**REZONING APPLICATION ANALYSIS**

**ZONING CASE #:** Z2014-23                      **LEGISTAR: #20141204**

**REQUEST:** PRD-SF (Planned Residential Development –  
Single Family)

#### *Planning & Zoning Comments for Boston Homes*

**BOSTON HOMES**  
REZONING PLANS

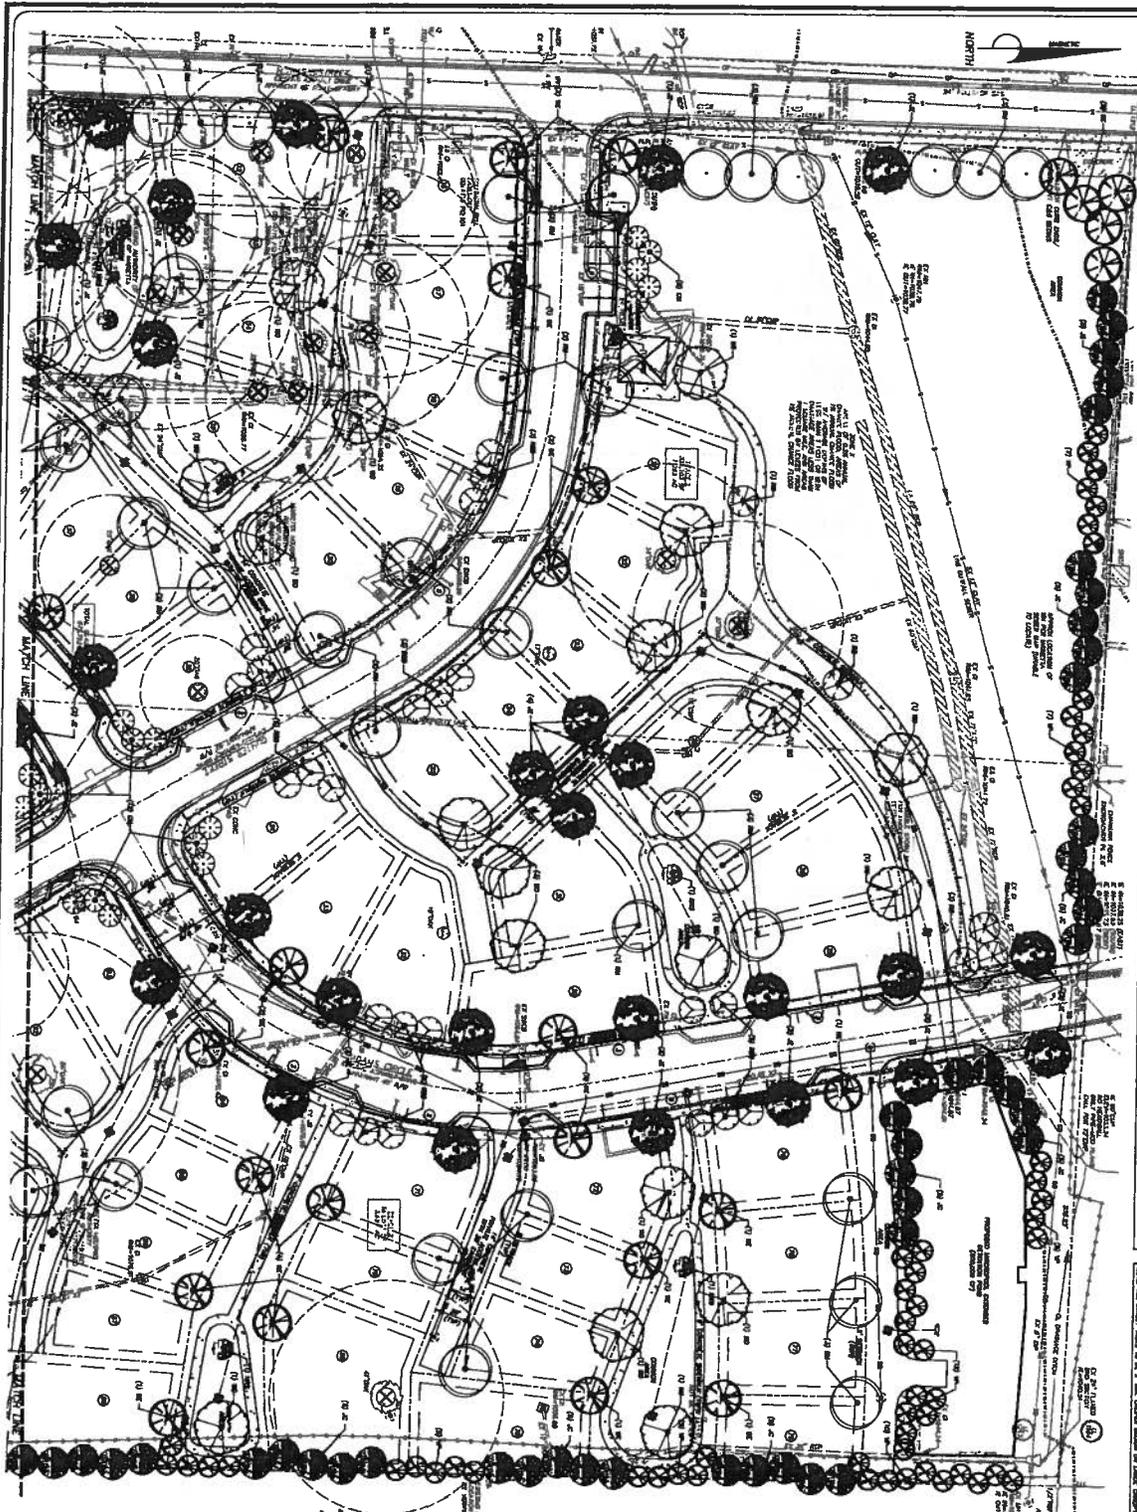
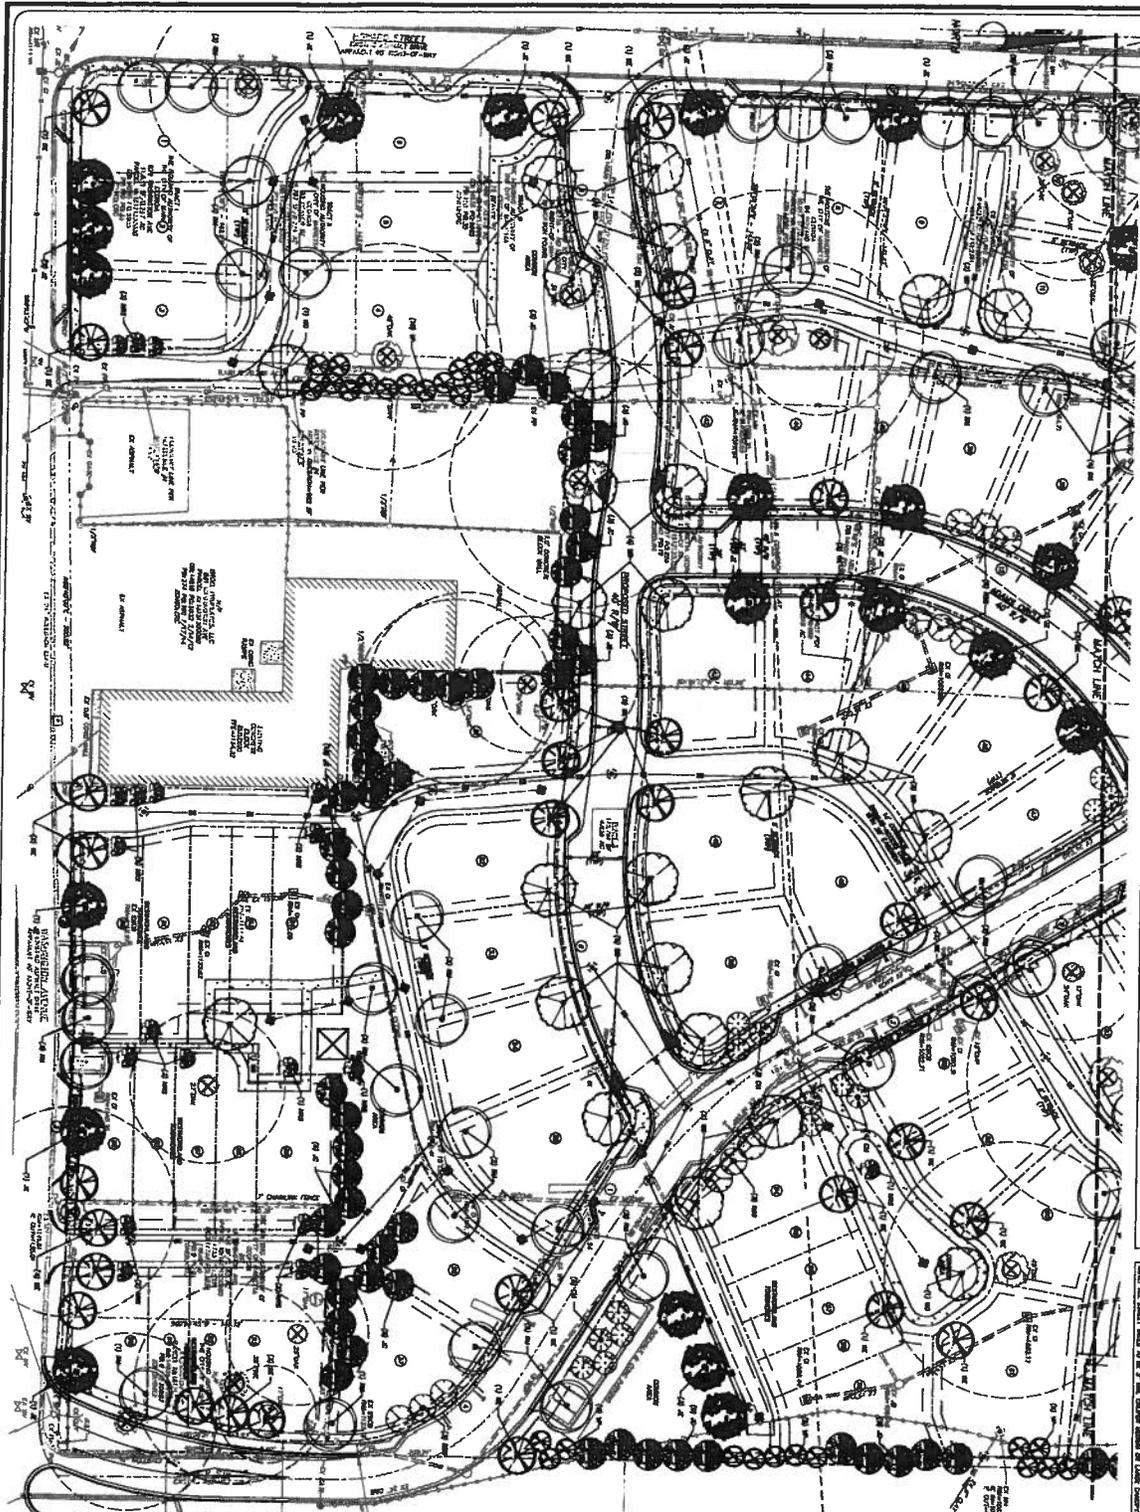
1. The project summary on the cover of the “Rezoning Plan” states that “***approximately 100 attached townhomes and single family lots***” will be built. If this plan is to serve as the detailed plan, it will establish the density, which cannot be adjusted. Please be specific about the number of units.

2. The detailed plan does not provide any parking information/totals. Each lot should have a two-car garage plus a driveway a minimum of 20’ deep in order to accommodate two additional cars. If the 20’ driveway length cannot be met due to curvature of the road or topographical issues, those spaces must be provided elsewhere on the site. Any request to vary these standards must be specifically identified in the motion to approve the detailed plan for the development. Attached units must provide 0.2 spaces per unit for guest parking.

- *A five foot setback does not leave enough room for the required driveway length or required tree plantings. See Note #14.*
3. Private alleys should only be included within developments as a secondary means of access to the rear or sides of buildings, and should not be substituted as a primary street. There are

- quite a few lots that are only accessed by alleyway.
4. The developer is required to install "No Parking" signs on all alleyways.
  5. All developments for which alleys are proposed shall be reviewed and approved by City Council at a regularly scheduled meeting as a **separate item on the agenda.**

6. Sidewalks should be located completely in the right of way or covered by an access easement.
  7. Right of way for public streets must be 50' minimum. These streets are shown at 40.'

8. Please mark which roads are public or private.
  9. The Beavers Street right-of-way will need to be abandoned and rezoned to implement the proposed plan.

10. Please provide the floodplain area for determining density of the site.
  11. Please provide exterior elevations for the units.
  12. Only single-trunk Crape Myrtles receive density credit. Please specify the Crape Myrtles shown on the plan will be single-trunk.

13. Eastern Redbuds are not considered medium or large canopy and cannot be counted as street trees.
  14. ***Note: Many of these densely developed subdivisions recently being built, especially ones with reduced setbacks, are having difficulty locating the trees shown on their detailed plans/civil plans. This is a result of the developer having to show proposed trees on a plan before a buyer has selected a floor plan/driveway layout for the lot.***

- Provide the following Boundary information:
  - Lot dimensions
  - Location and description of easements (location, width, purpose & controlling entity) – 20' for storm and sanitary sewer

- Provide Street / alley names for homes fronting on them if addressed that way.
- Provide Lot addresses
- Provide the following Flood plain information (www.georgiadfirm.com):

- Location and elevations on each affected lot or state none exists – FFE must be at least 3' above BFE per Cobb GIS topo.
  - Reference to the latest FEMA information (effective November 2, 2012)

- Benchmark location and elevation tied to an acceptable control point.
- Show limits and base flood elevations of the flood plain. The new FEMA FIRM was updated effective November 2, 2012. Using the Cobb GIS topography, estimate the base flood elevation utilized for the estimated flood plain (where the flood plain line intersects a topo line).

- Clearly delineate on all affected plan sheets the 25' mandated State Stream Buffer, the additional 25' City Stream Buffer, and the additional 25' Impervious Area Setback (total 75') per

the Stream Buffer Ordinance at the downstream end of the pipe.

Abandonment of the R.O.W. of Beaver Street, Adams Circle, and Gunter Street as may be necessary will allow reconstruction of the roads with proposed parking along the sides.

The road widths (asphalt paving) for Beaver St, Adams Circle, & Gunter Street must be at least 20' in addition to 8' wide by 22.5' long parallel parking spaces (minimum). The drive for townhomes at southeast corner is too narrow.

Rights-Of-Way for Beaver St, Adams Circle, & Gunter Street are to be at least 50' or abandonment approved by Council. Where private parking is proposed, the R.O.W. may be lessened with an access easement for the parking spaces as well as the sidewalk. The City will not accept the parking spaces within R.O.W.

Minimum Radii of street C/L 100'.

Minimum curb radius is 25 ft including for alleys. However, Fire Dept may require 35'.

A 5' sidewalk with 2' grass strip along the curb of all roads is required. If additional R.O.W. is required in order for the sidewalk to remain in the R.O.W., then a Quit Claim deed will be required.

150 ft. acceleration and deceleration lanes with 50 ft. tapers are required on Washington Avenue. Accel / Decel lanes are required by Ordinance on all roads classified Collector or Arterial.

Curb ramps with crosswalks to be located at all intersections within City Right-of-Way (see above), or across private alleys. Show crosswalks, ramps, and stop signs.

Right-of-Way donation on Washington Avenue will require an executed Quit Claim Deed be provided to the City *prior to One-Stop approval*. The R.O.W. shall be at least 25' from centerline on the property side. With sidewalk as noted above.

- Where sanitary and / or storm sewer lines are shown outside the private access drive easement (revise all to access / utility easement), provide easement (such as lots 70 & 71, or 15, 16, 17). Remember that the easement is provided so the pipe excavation may be made if necessary in the future. Easements must be provided even if within private property or common areas.

1. Fire department access roads shall have an unobstructed width of 20 feet. Entrances and gated roads may be 14 feet wide where approved. **Note:** Proposed alleys depict 14feet; however, direction of travel along the alley is not shown on the plan.
2. Sprinkler protection required for all new one and two family dwellings built closer than 10 feet to a property line or closer than 20 feet to another structure.
3. Fire department access roads shall have the proper turning radii of 35 feet.
4. Designated "Community Mail Box" parking areas shall provide "Accessible Parking."
5. Fire Hydrants shall be provided within 600 feet of all portions of Group R-3 buildings.
